SHEFFIELD CITY COUNCIL Cabinet Highways Committee

Subject: Cultural Industries Quarter Public Realm
Regeneration Project

Sheffield City Council
 Scheme: CULTURAL INDUSTRIES QUARTER
 Drawing Title: ARUNDEL STREET/CHARLES STREET CONSULTATION PLAN

SCHEME CONSULTATION SUMMARY

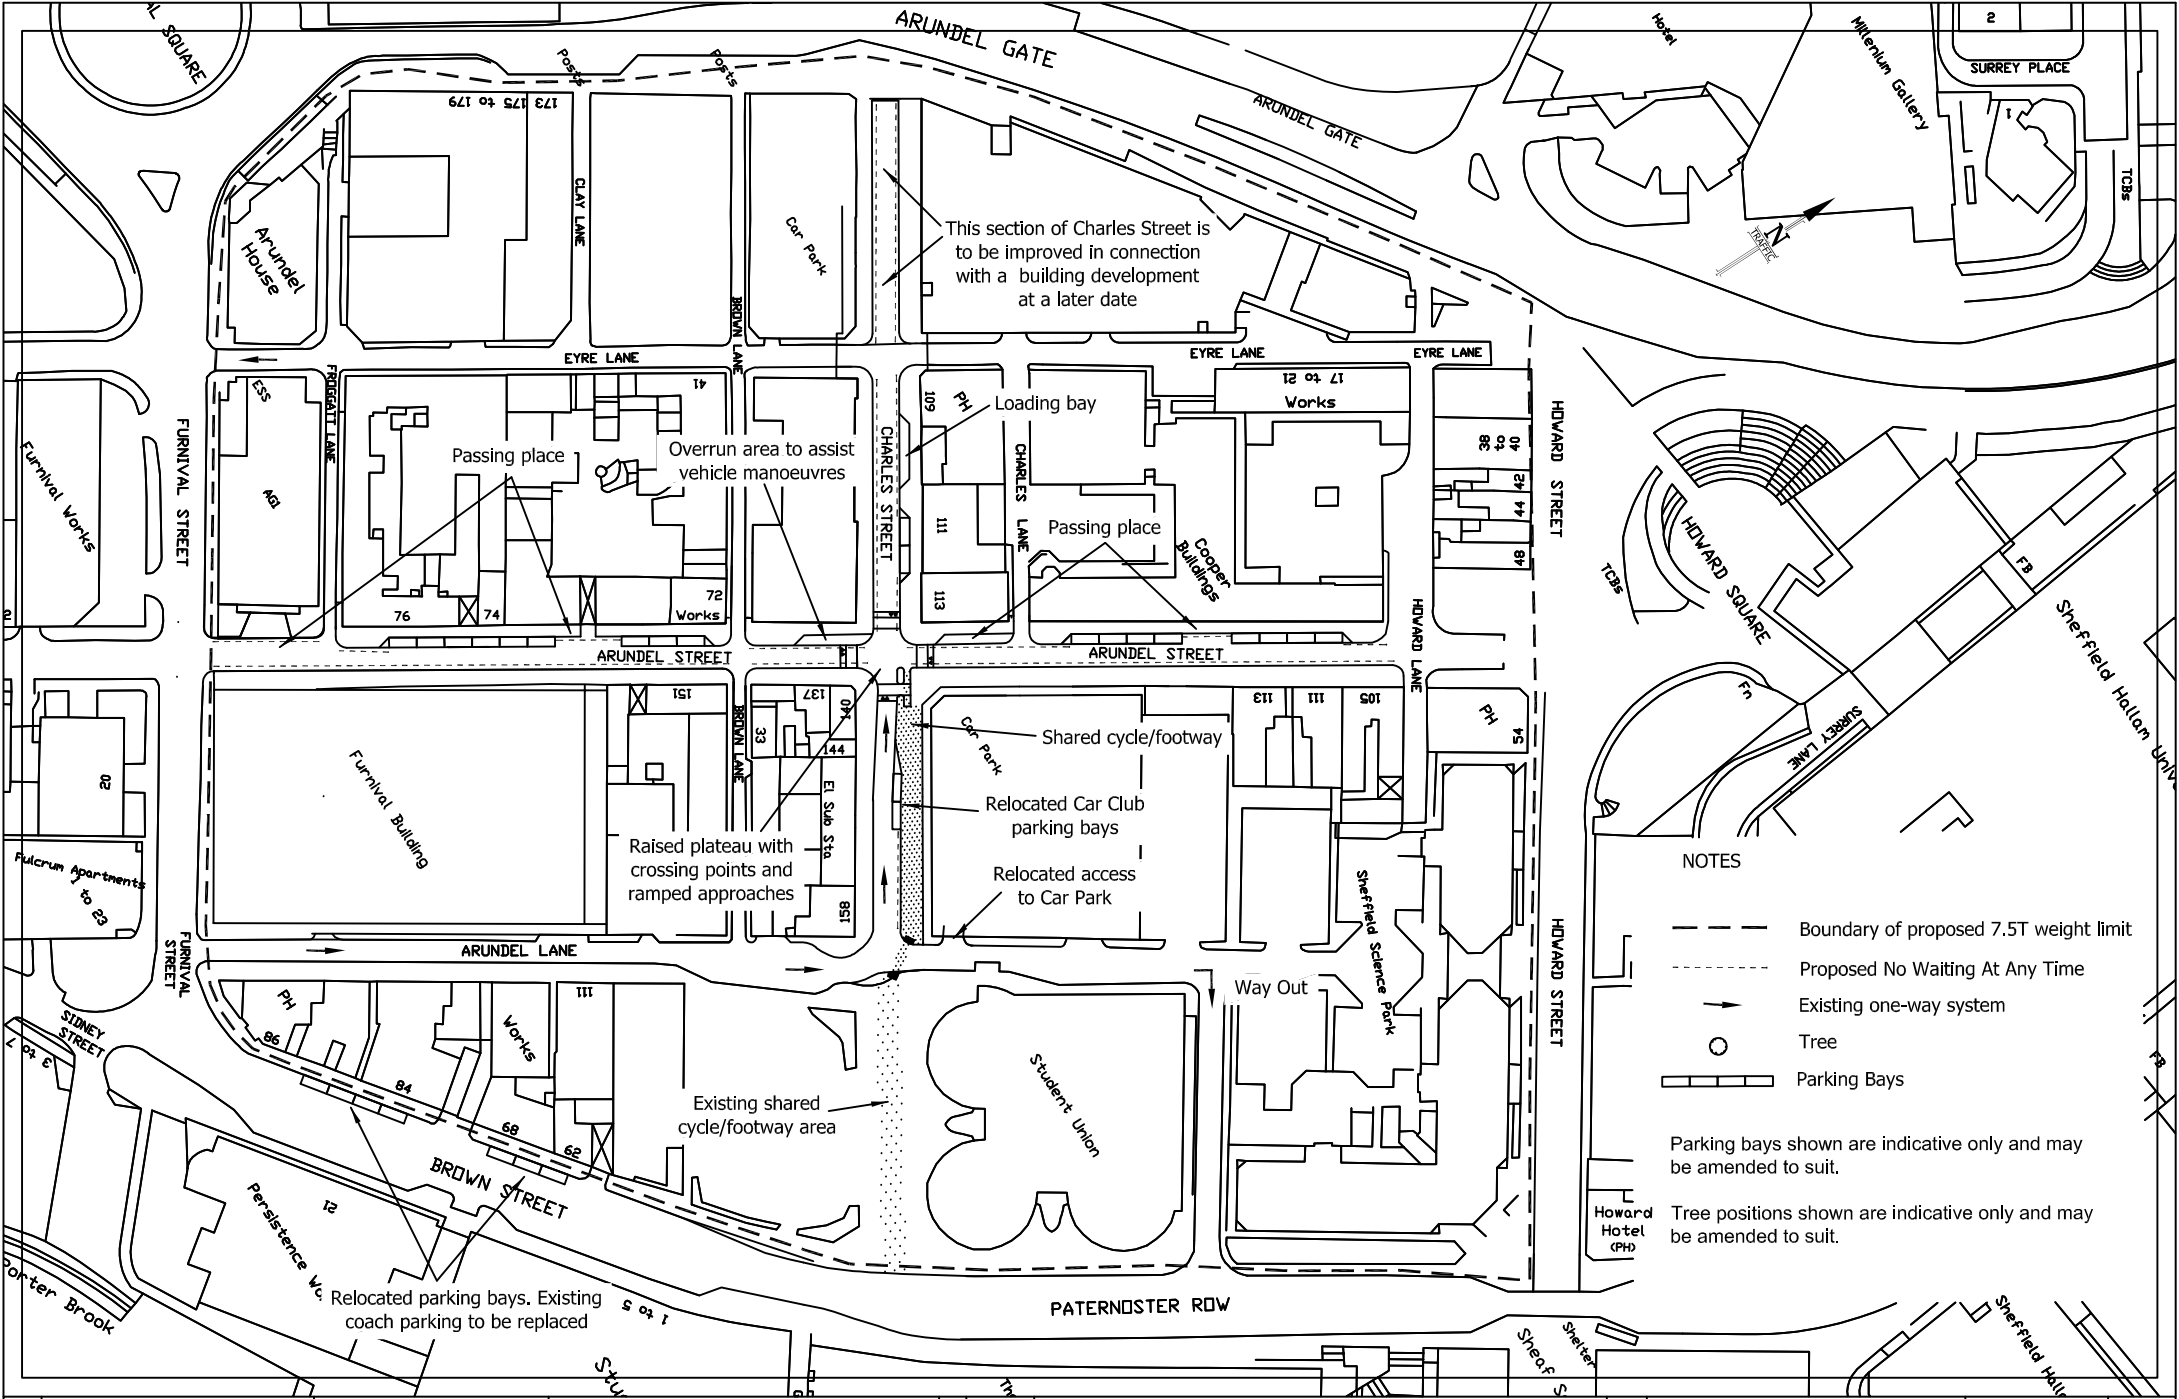
7. The exit from the AG1 apartment block will be made dangerous for vehicles leaving the car park.

8. The proposed parking bays to be re-located onto Paternoster Row near The Workstation will interfere with deliveries at the adjacent doorway. Also, coaches u-turn in the Science Park car park egress and may also be restricted by the bays.
Response – This location and the comments received will be investigated. If necessary, the scheme will be revised as there is an alternative location which could be utilised for the bays.

25. The passing place shown at the Cooper Building is in the wrong place and is not large enough for the vehicles which will use it.

Response – The layout of the road and footway immediately outside the AG1 block is not being altered. However, the opposite footway will be increased in width taking it closer to the AG1 building. Manoeuvres here will be checked and amended if necessary to allay any fears the residents have.

Response – This is not the case, and we are confident that the passing place is suitably sized. In reality, the whole of a vehicle does not need to be accommodated in the passing place. It will provide somewhere where there is an opportunity to pull over slightly, whilst vehicles pass one another. The passing place is located directly in front of the main entrance to the building to keep the façade clear. This is in line with conservation requirements. For the same reason the façade of Butcher Works has been left clear.
